Cree LED HB SMD LED Product Change Notification

PCN-06063

April, 2024

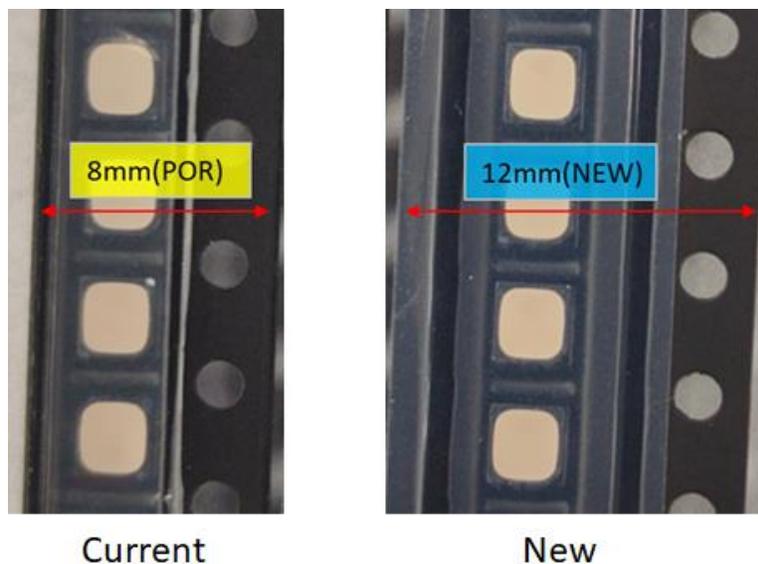
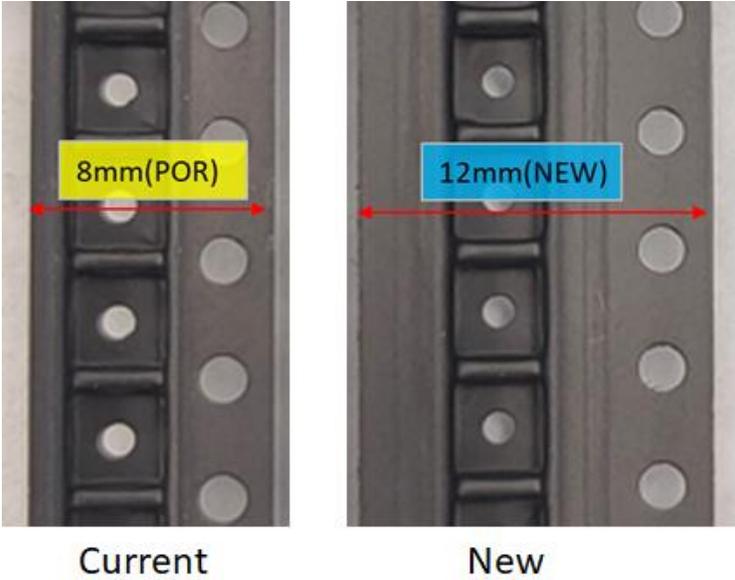
Cree LED qualified an alternative carrier tape for LY6 product series. The current and new carrier tape differences are shown below:

Strengthen stability at customer’s pick and place process.
